工程指示 / 要求簡箋 ENGINEER INSTRUCTIONS (E.I.)

| 工程指示編號: | EI- 4790D | 修改版本: | D |
| 工程編號: | J 853 | 工程名稱: | 大窩坪 (延坪道) |
| 工程項目: | T3 幕牆單元件生產 (大貨) (修訂D:修改Z字碼設計及修改分格呎吋) | 日期: | 29/07/2022 |

| 名稱 | 梗邊企 | 制圖 | 陳敏聰 | 2022.05.02 | 修改 | A | |

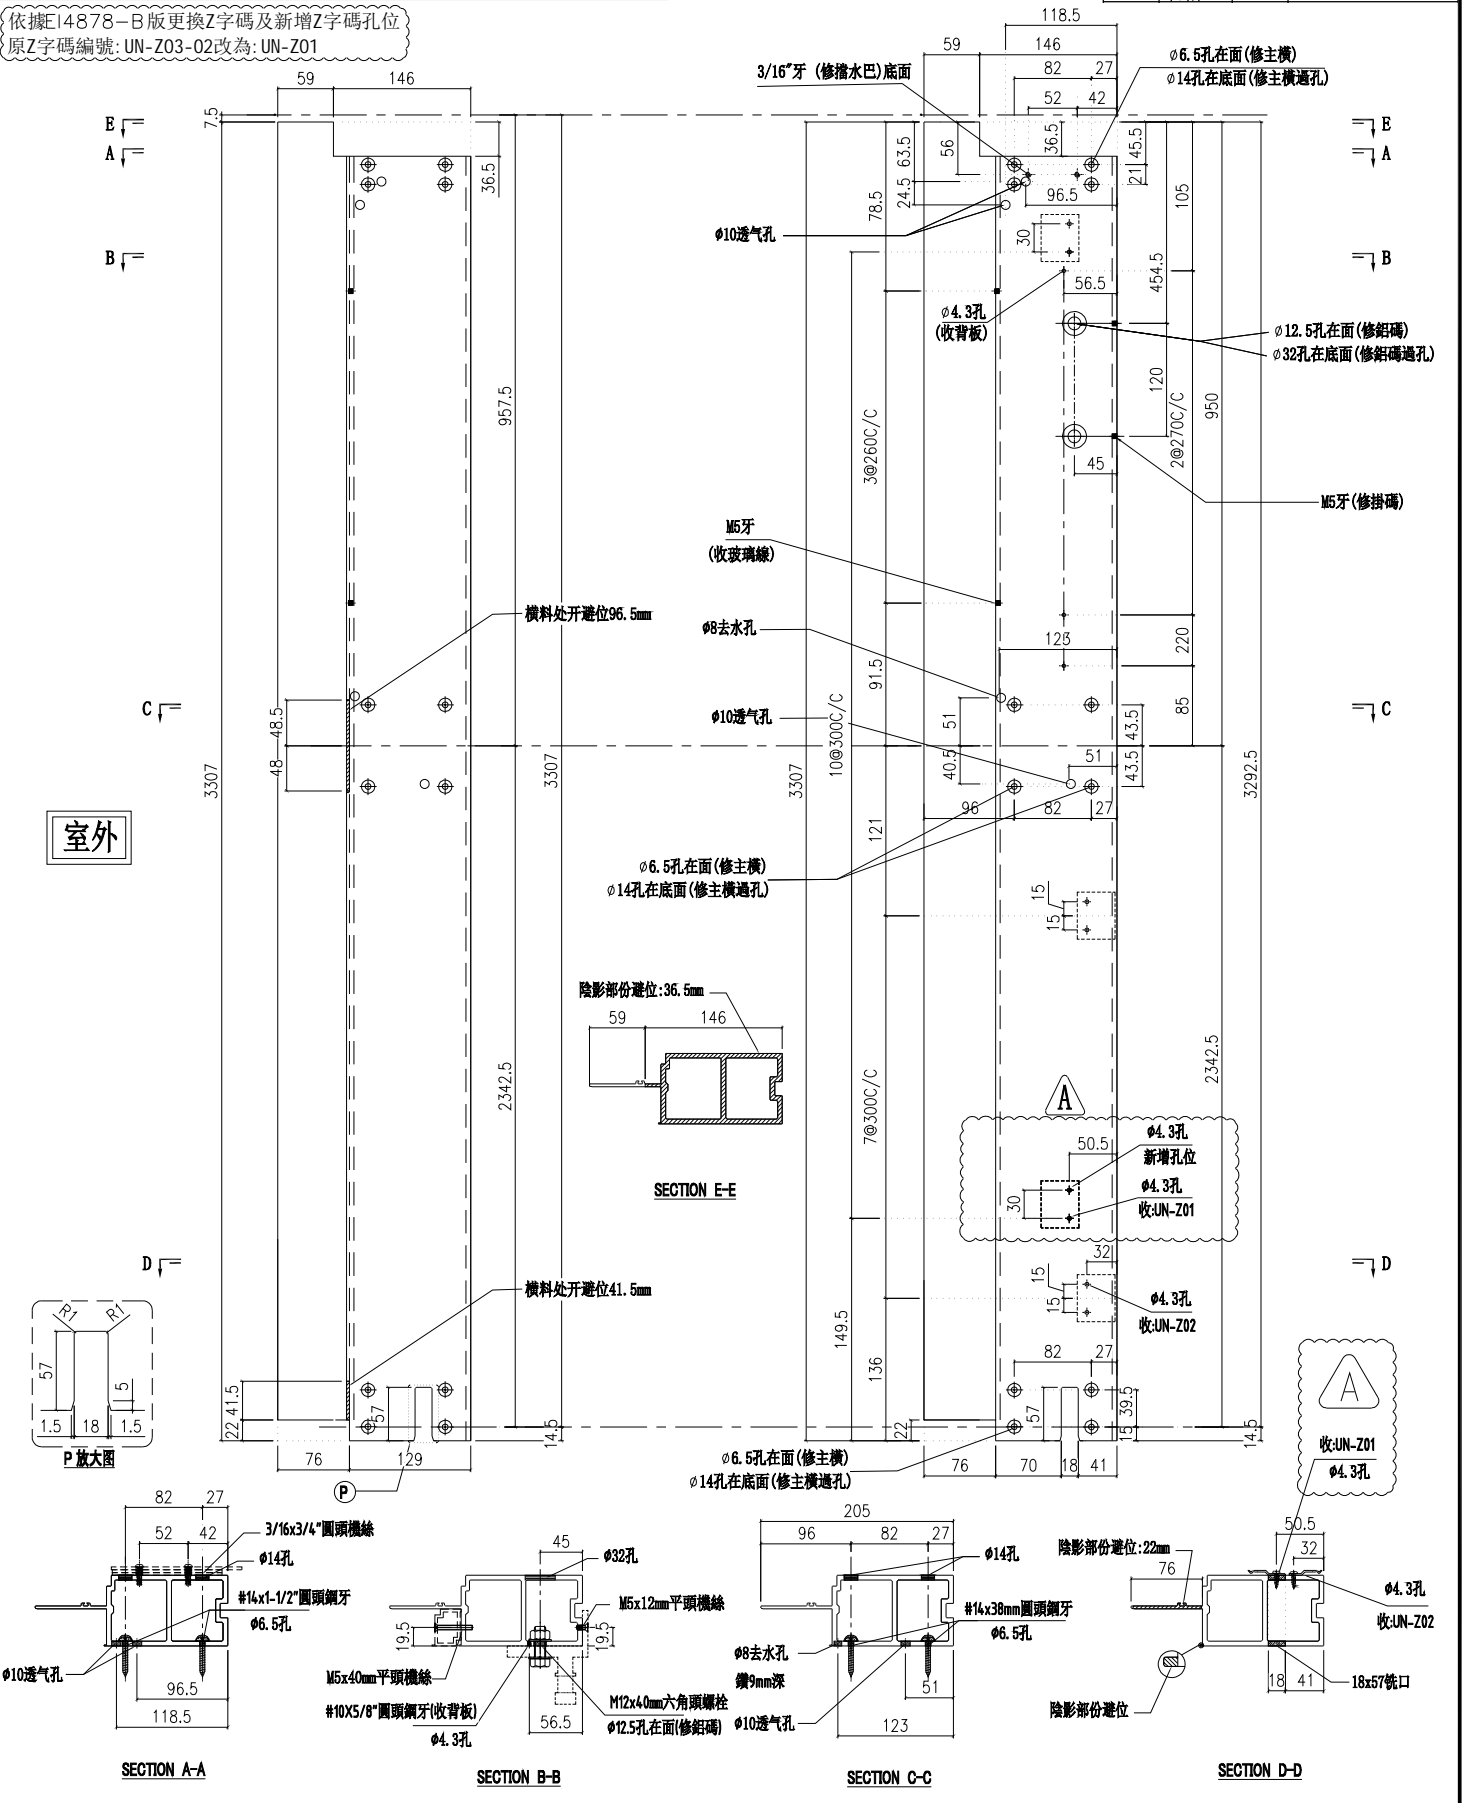
依據E14878-B版更換Z字碼及新增Z字碼孔位
原Z字碼編號: UN-Z03-02改為: UN-Z01

| 名稱 | 梗邊企 | 制圖 | 陳敏聰 | 2022.05.02 | 修改 | A | |

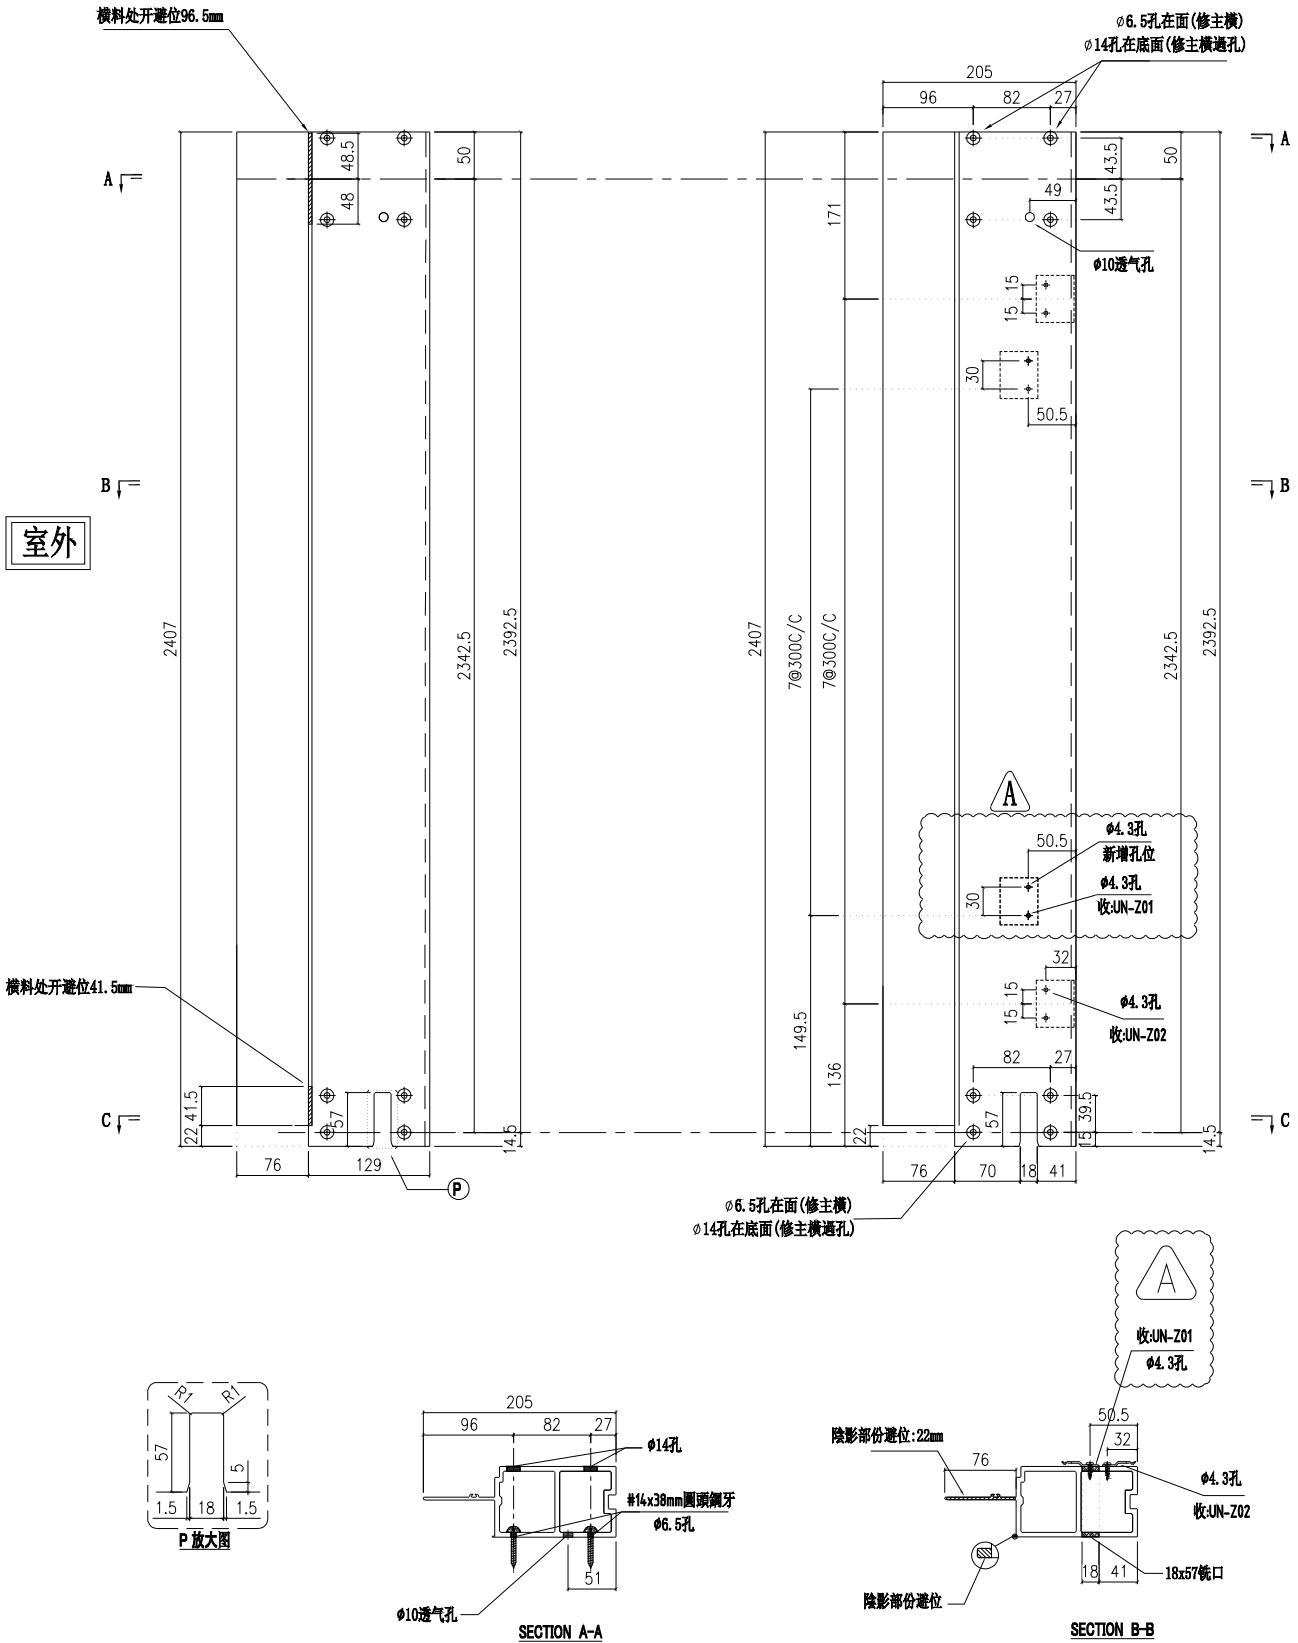
依據E14878-B版更換Z字碼及新增Z字碼孔位
原Z字碼編號: UN-Z03-02改為: UN-Z01

| 名稱 | 梗邊企 | 制圖 | 陳敏聰 | 2022.05.02 | 修改 | A | |

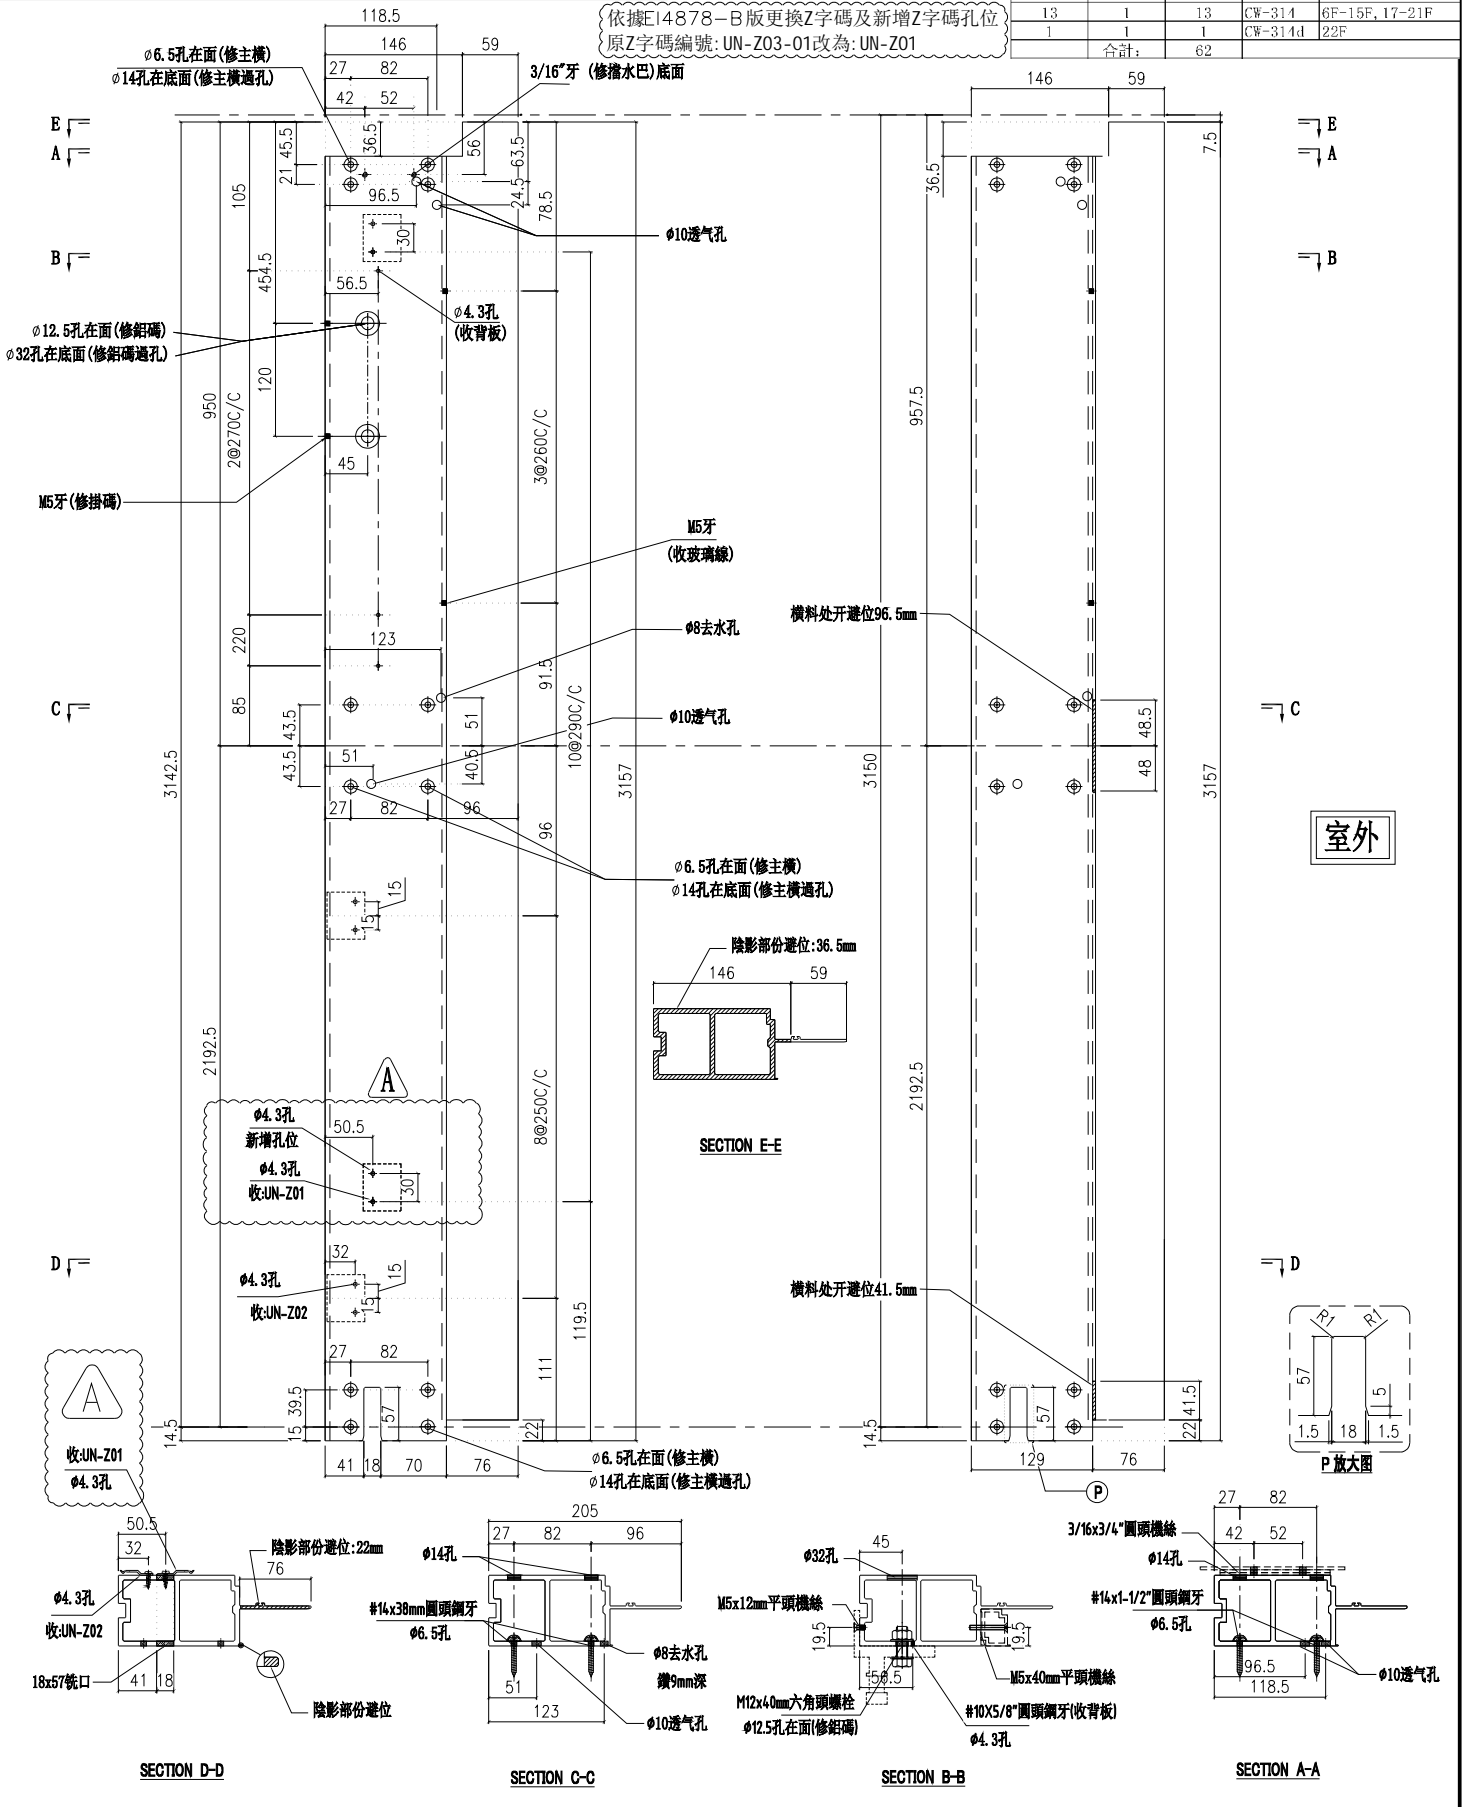
依據E14878-B版更換Z字碼及新增Z字碼孔位
原Z字碼編號: UN-Z03-01改為: UN-Z01

| 名稱 | 梗邊企 | 制圖 | 付吉寧 | 2022.04.06 | 修改 | A |

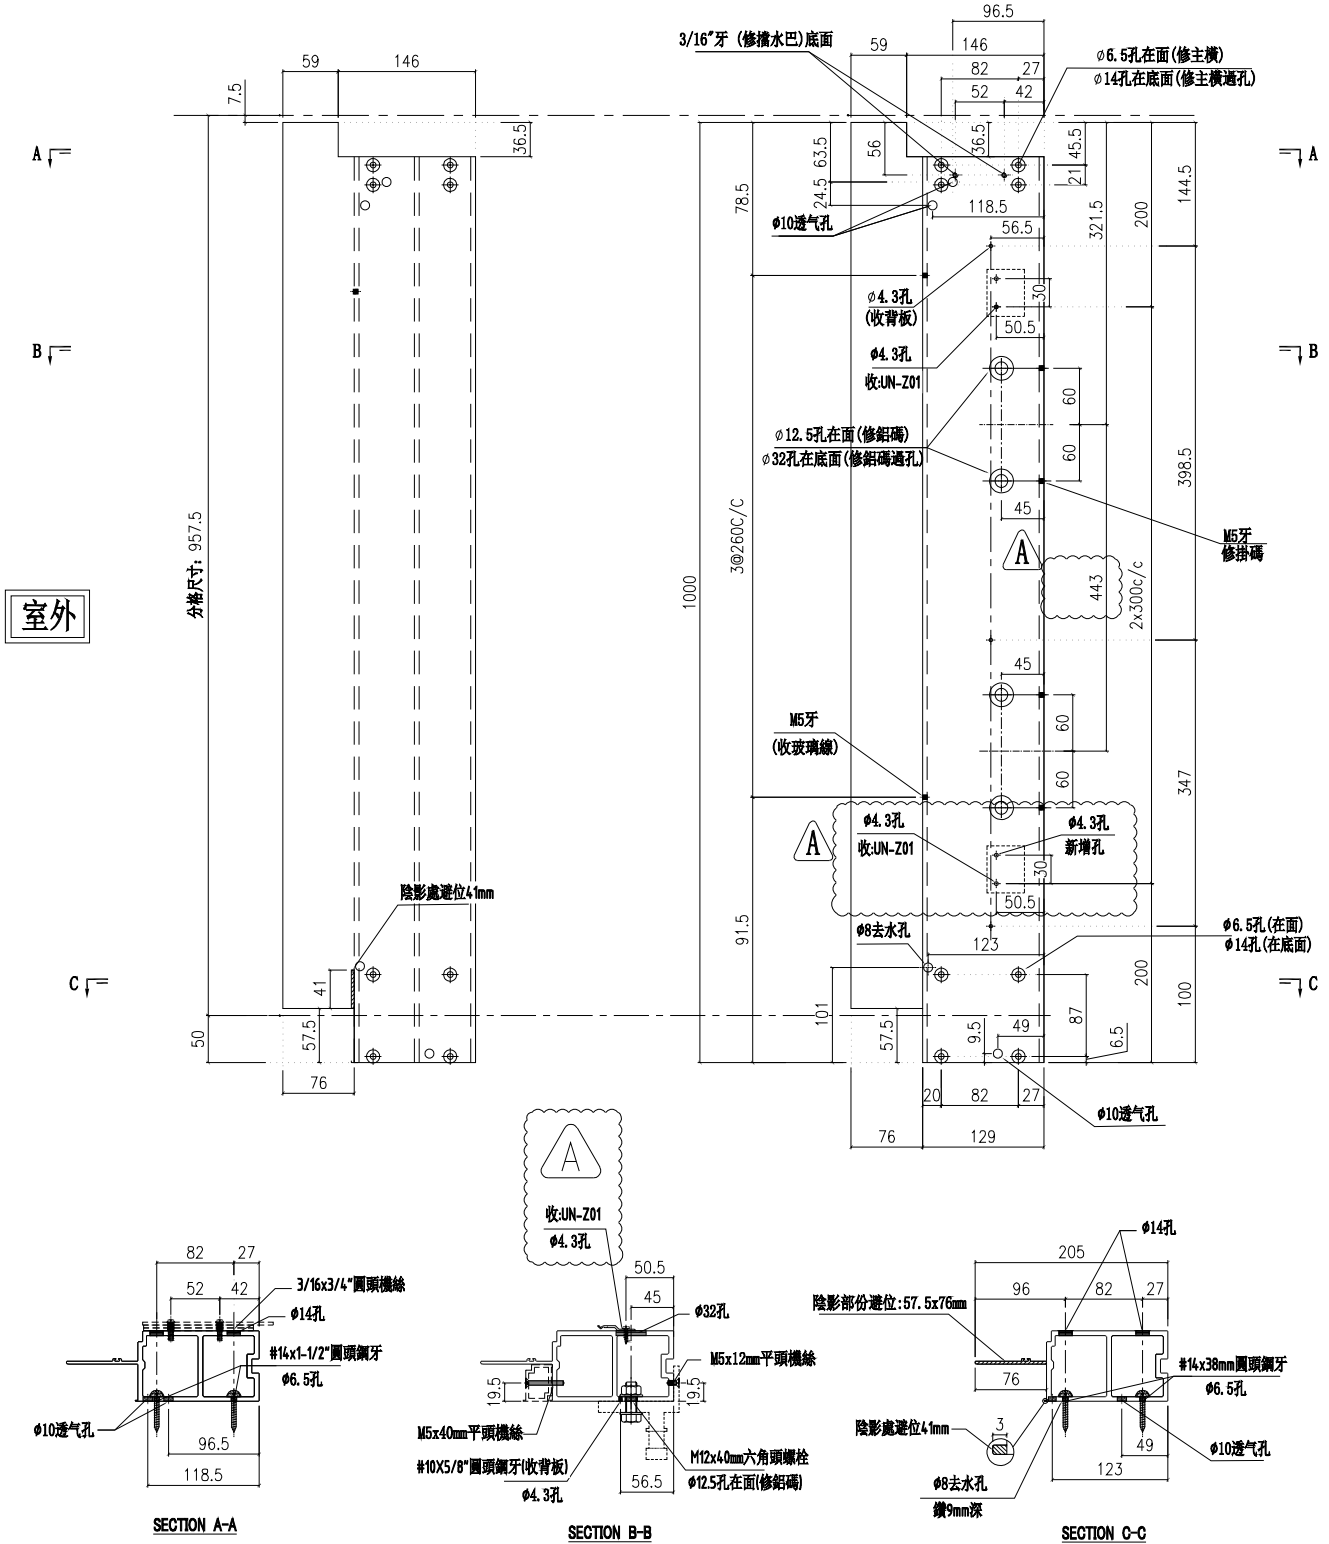
依據EI4439-A修改雙掛碼孔間距
 依據EI4878-B版更換Z字碼及新增Z字碼孔位
 原Z字碼編號: UN-Z03-01改為: UN-Z01
